City of Puyallup Development & Permitting Services ISSUED PERMIT			
Building	Planning		
Engineering	Public Works		
Fire	Traffic

PRFUP20241583

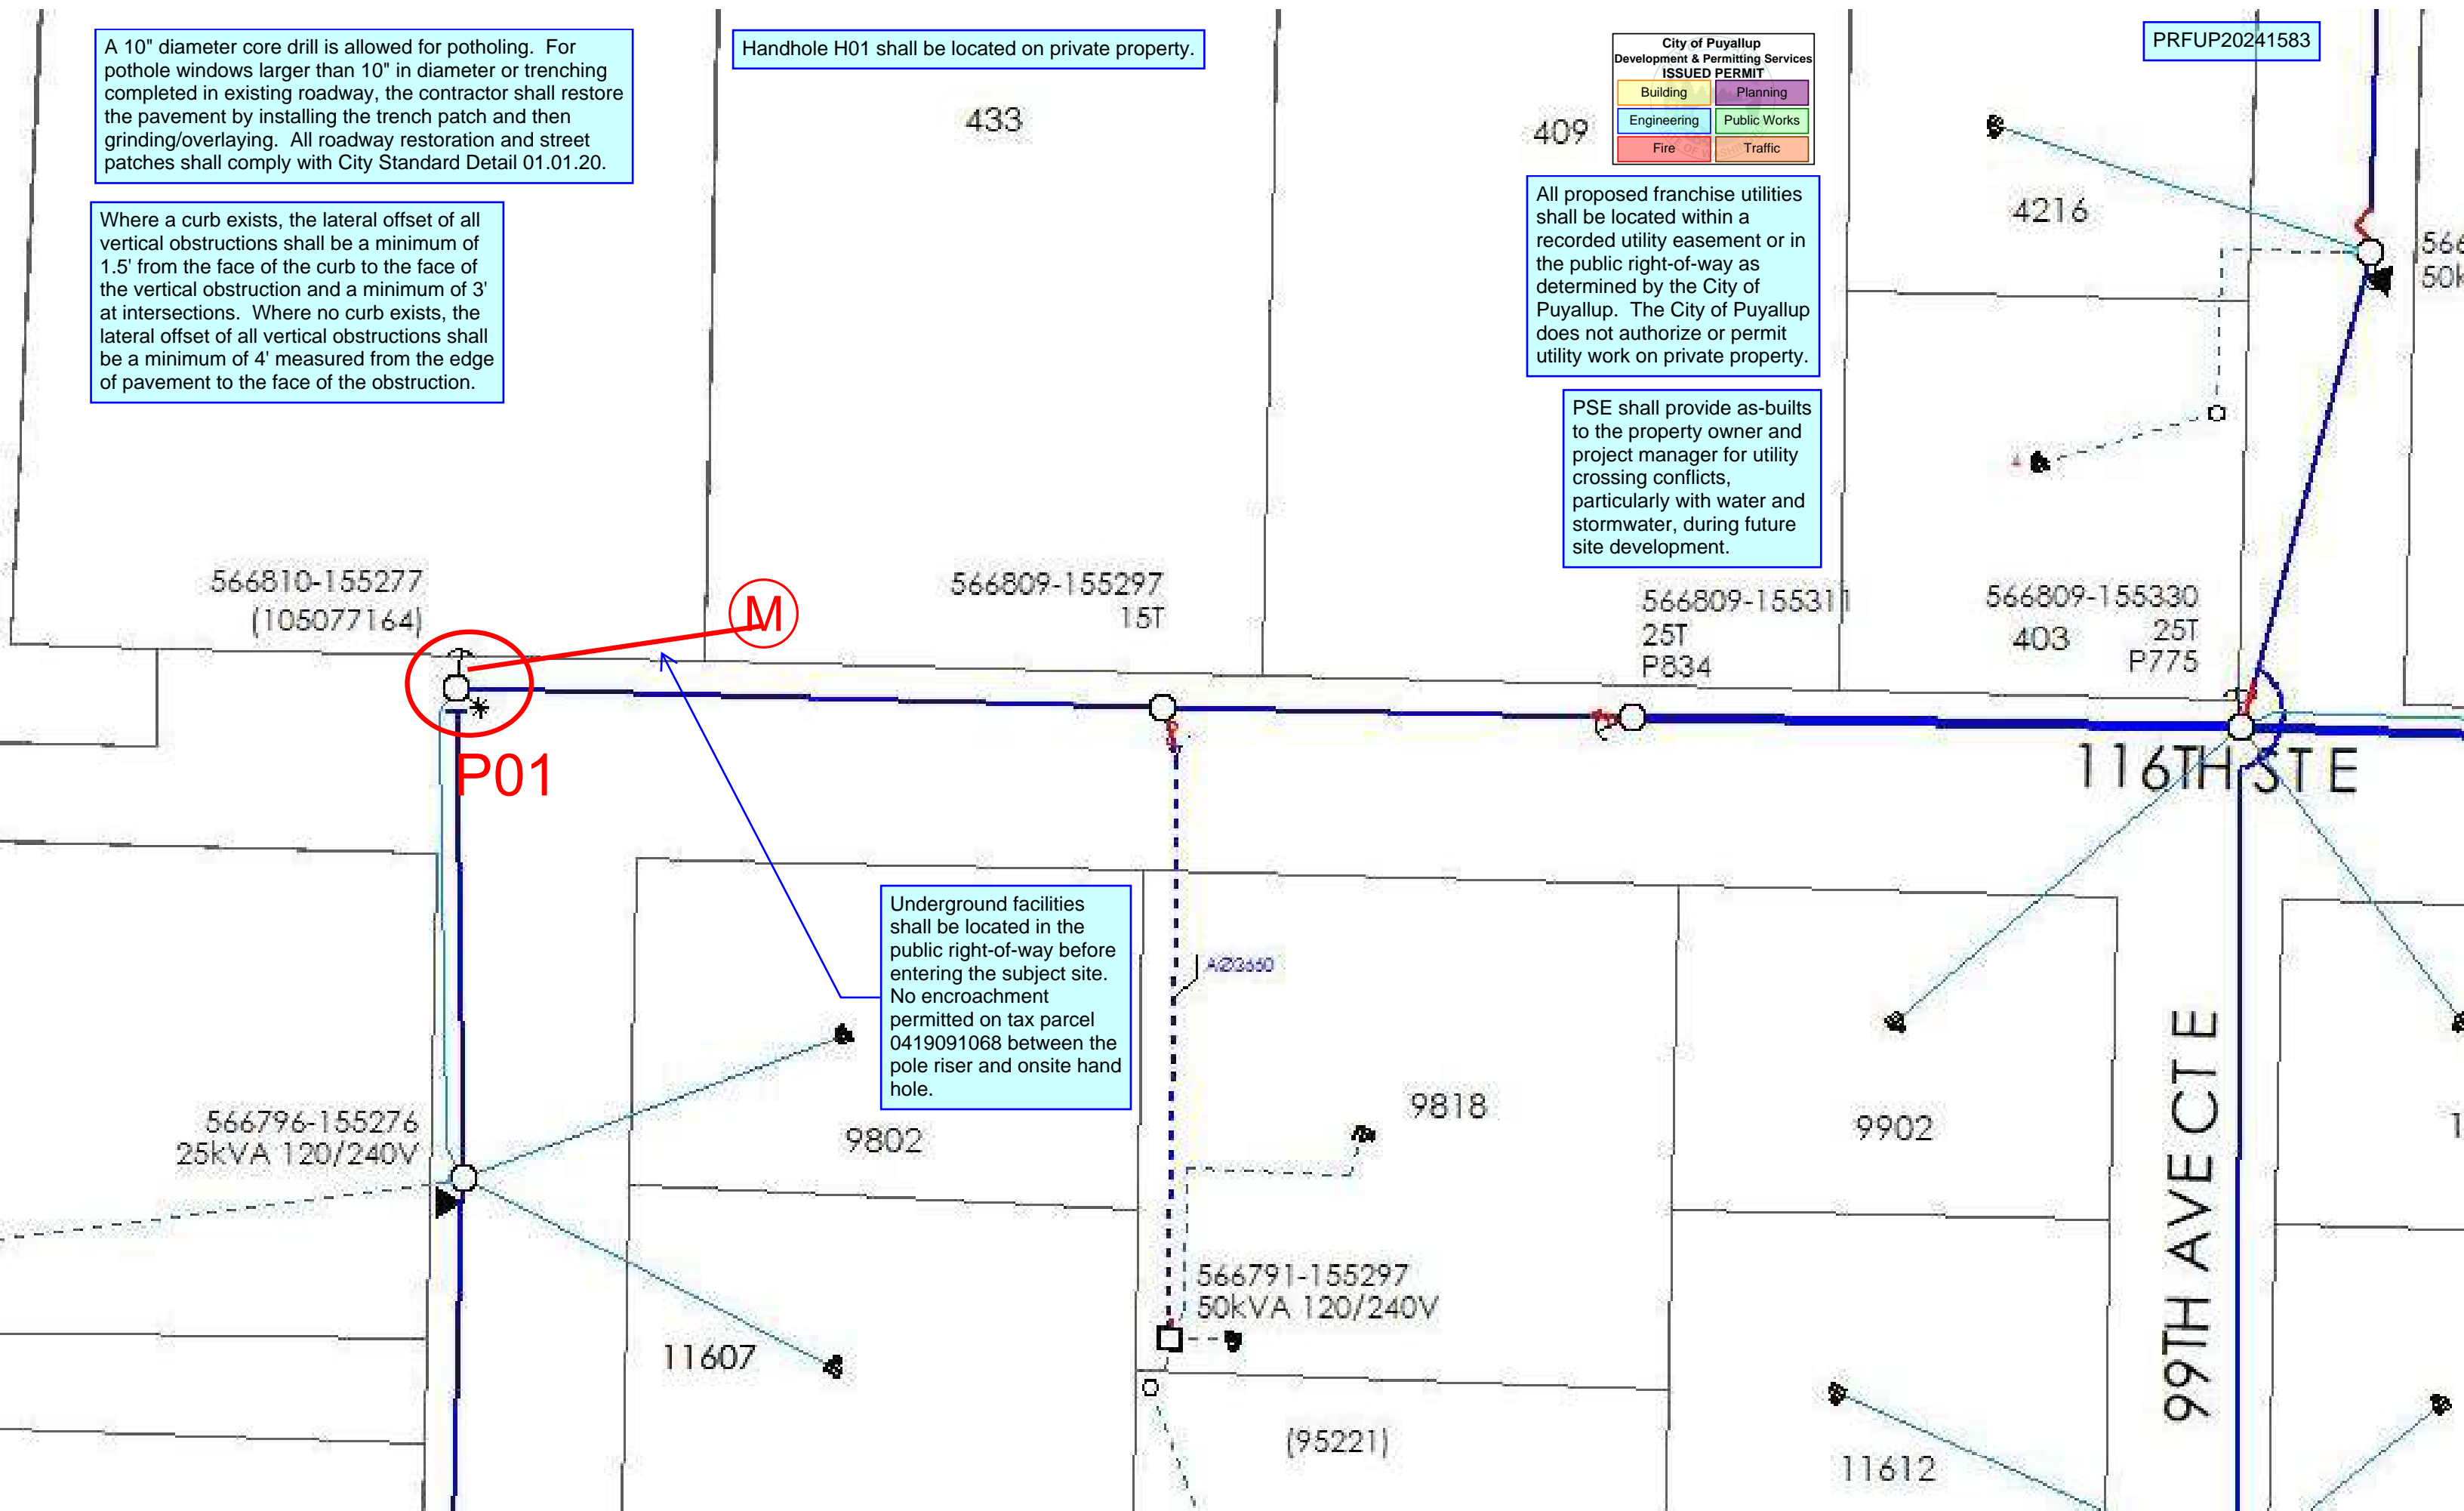
A 10" diameter core drill is allowed for potholing. For pothole windows larger than 10" in diameter or trenching completed in existing roadway, the contractor shall restore the pavement by installing the trench patch and then grinding/overlaying. All roadway restoration and street patches shall comply with City Standard Detail 01.01.20.

Where a curb exists, the lateral offset of all vertical obstructions shall be a minimum of 1.5' from the face of the curb to the face of the vertical obstruction and a minimum of 3' at intersections. Where no curb exists, the lateral offset of all vertical obstructions shall be a minimum of 4' measured from the edge of pavement to the face of the obstruction.

Handhole H01 shall be located on private property.

All proposed franchise utilities shall be located within a recorded utility easement or in the public right-of-way as determined by the City of Puyallup. The City of Puyallup does not authorize or permit utility work on private property.

PSE shall provide as-builts to the property owner and project manager for utility crossing conflicts, particularly with water and stormwater, during future site development.

Underground facilities shall be located in the public right-of-way before entering the subject site. No encroachment permitted on tax parcel 0419091068 between the pole riser and onsite hand hole.
